CHESTER ROAD – NMA DESIGN DOCUMENT

1. Typical shower rooms layouts compliance.
2. Proposed reduced overall building height.
3. Proposed new roof maintenance access ladder.

CHESTER ROAD – shower rooms

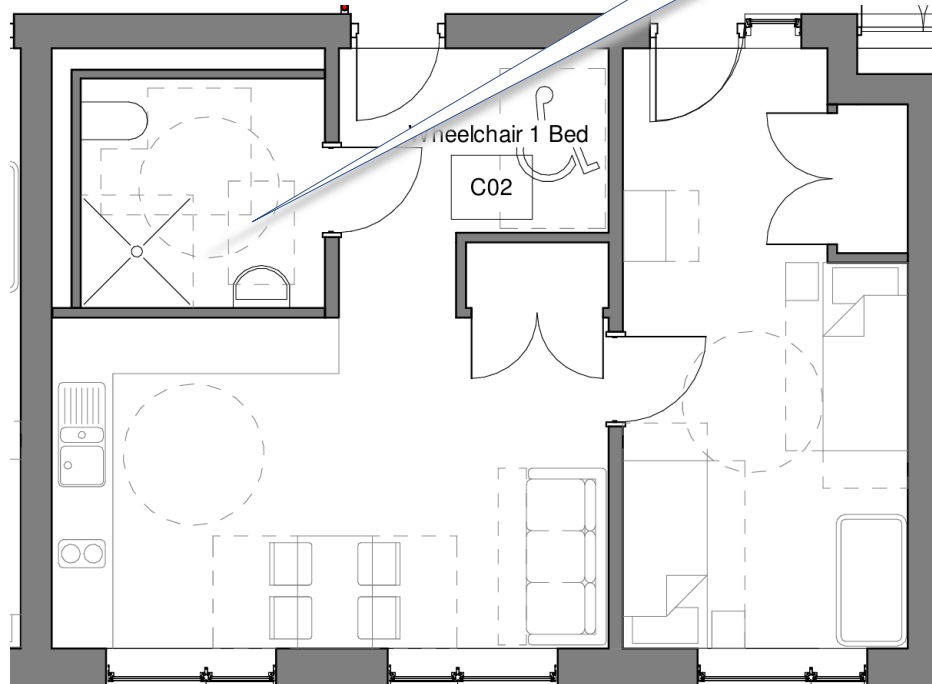
Sui Generis use class is not subject to compliance with AD Part M and it is evident that the unit layouts developed by the original architects working closely with the LBC Homeless Team were not designed to achieve AD Part M4(2) compliance. The shower tray arrangement was preferred by the client's Team as the most suitable for the units.

In order to achieve compliance with AD Part M4(2) a level access shower and a 300 mm unobstructed door nibs would need to be introduced which would have an impact of the internal circulation arrangements.

Based on the above comments we would apply to vary the wording of the Condition 4 pursuant to planning permission 2020/3461/P to replace AD Part M4(2) reference with M4(1) Visitable Dwellings. The M4(1) compliant shower room layouts will be larger compared to the shower rooms shown on the approved drawings which will allow greater flexibility for the users.

Proposed AD Part M(4)1
Compliant shower room

Proposed AD Part M(4)3
Compliant shower room

CHESTER ROAD – building height

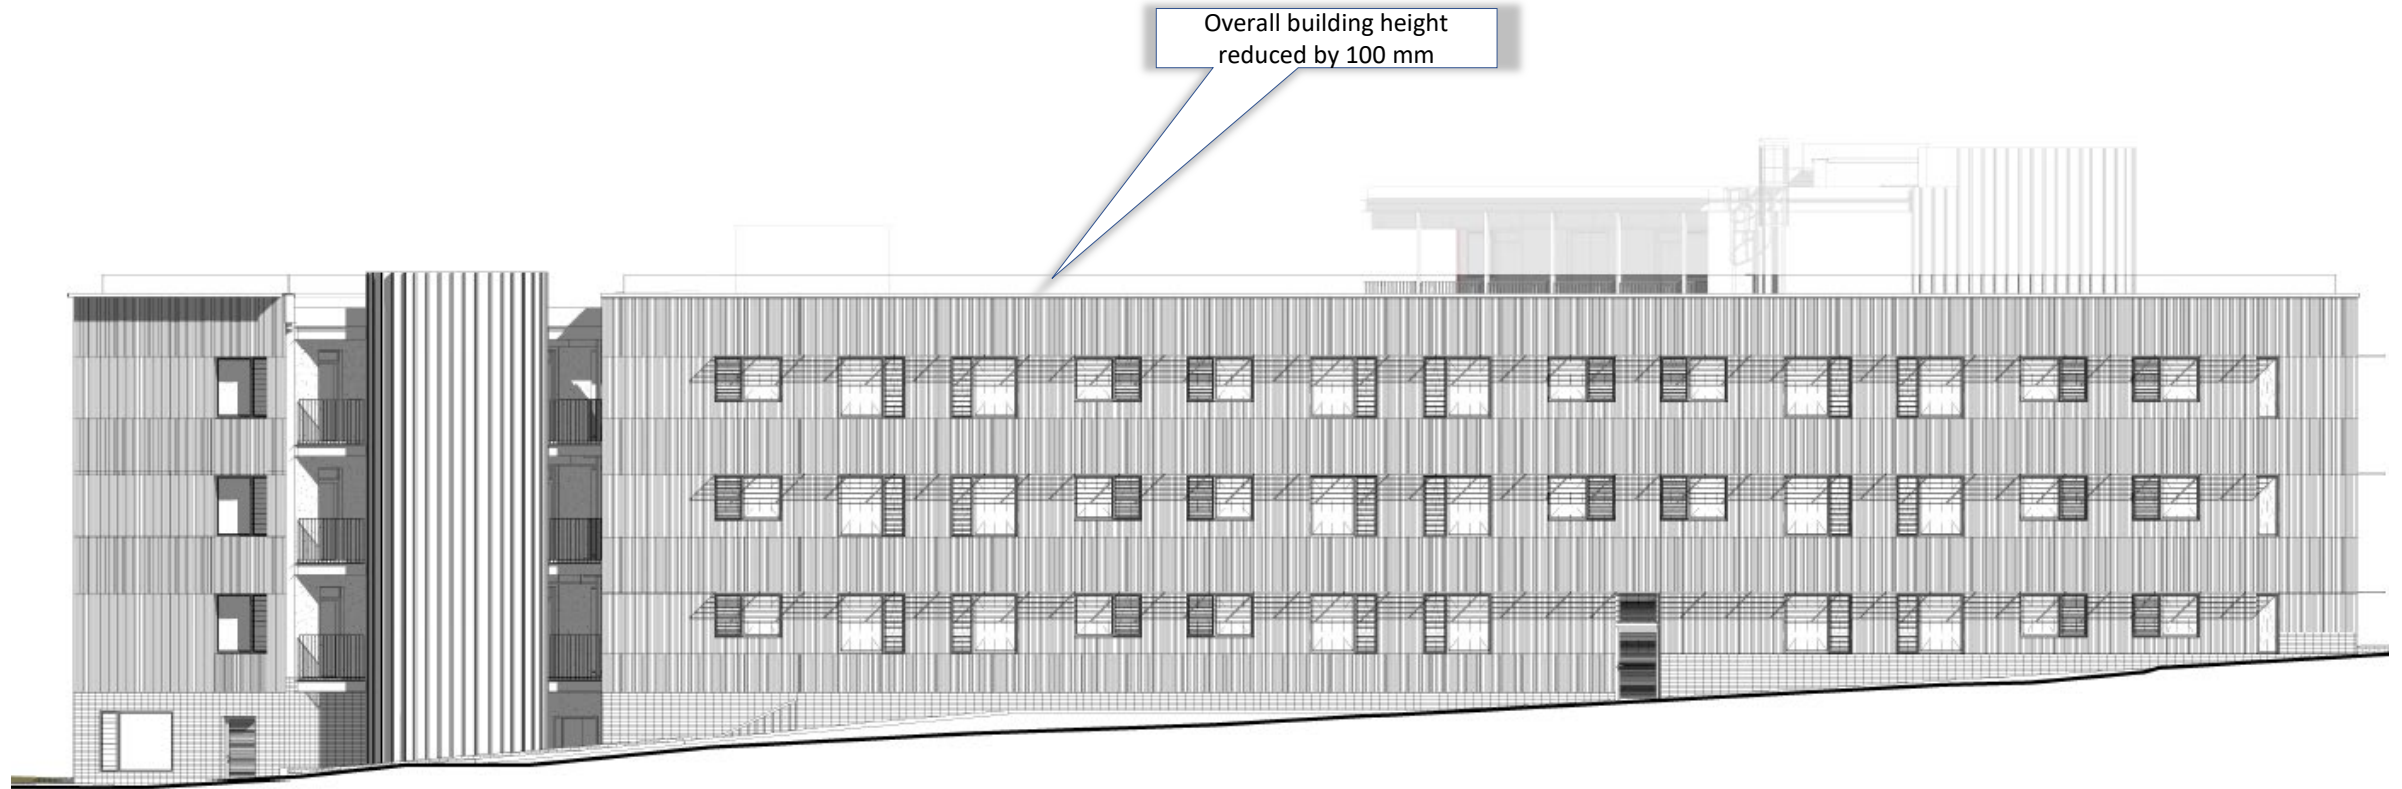
The original design, showed on the current planning application drawings was based on a Volumetric Modular Construction design.

The current design is based on a Light Gauge Steel construction system (LGS). It allowed to avoid the duplication of the floor/ceiling spaces of the individual volumetric units, hence allowed for the reduction of the storey height.

The overall floor to floor height reduction allowed to achieve the lower whole building heights by 100 mm.

CHESTER ROAD – Block C: new roof access ladder

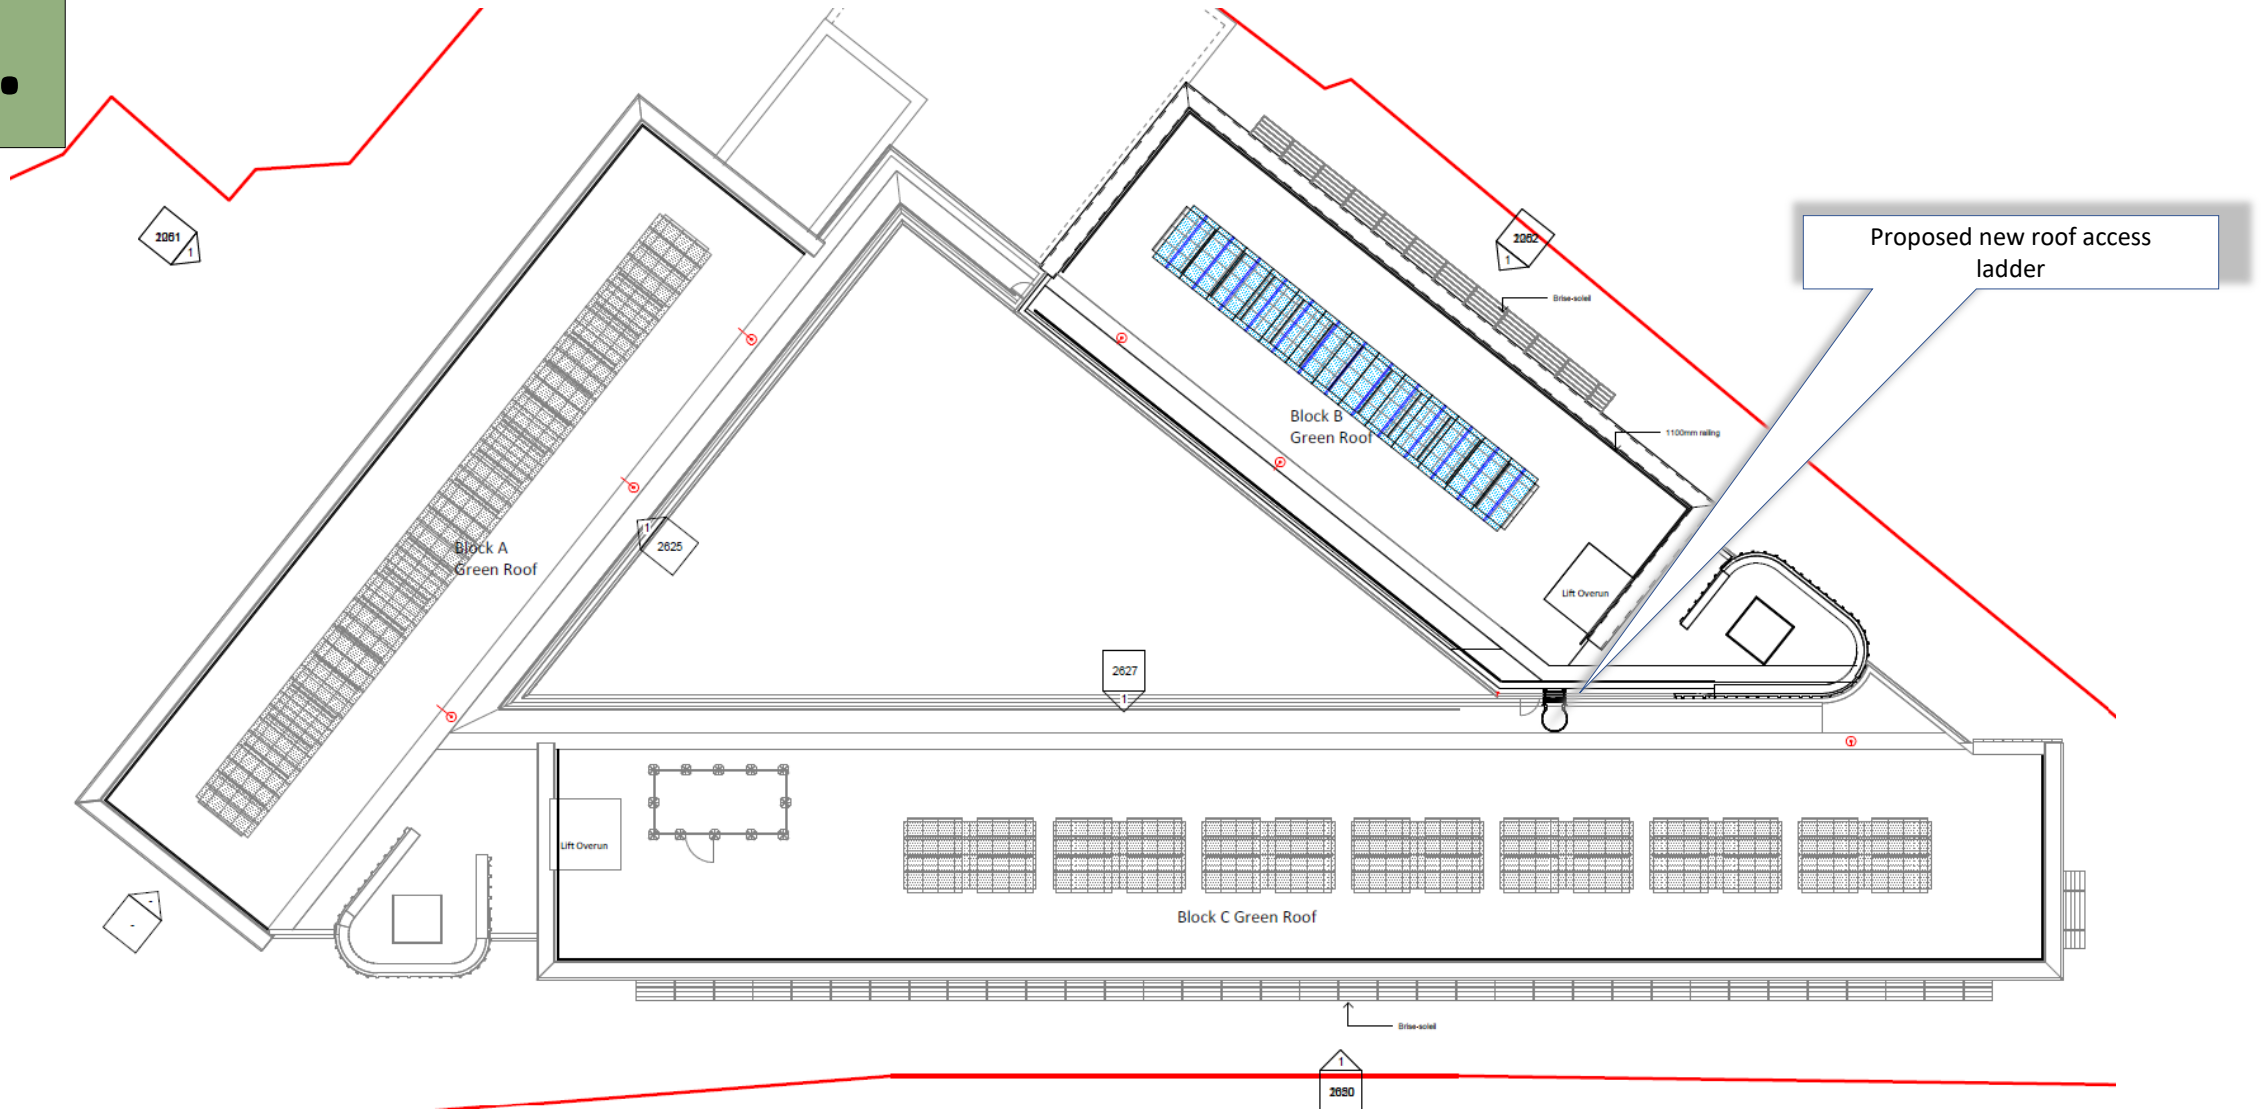
Additional access ladder will be required to facilitate safe maintenance access to Block B roof.

The maintenance ladder will be constructed from galvanised mild steel flat sections to achieve a low maintenance finish.
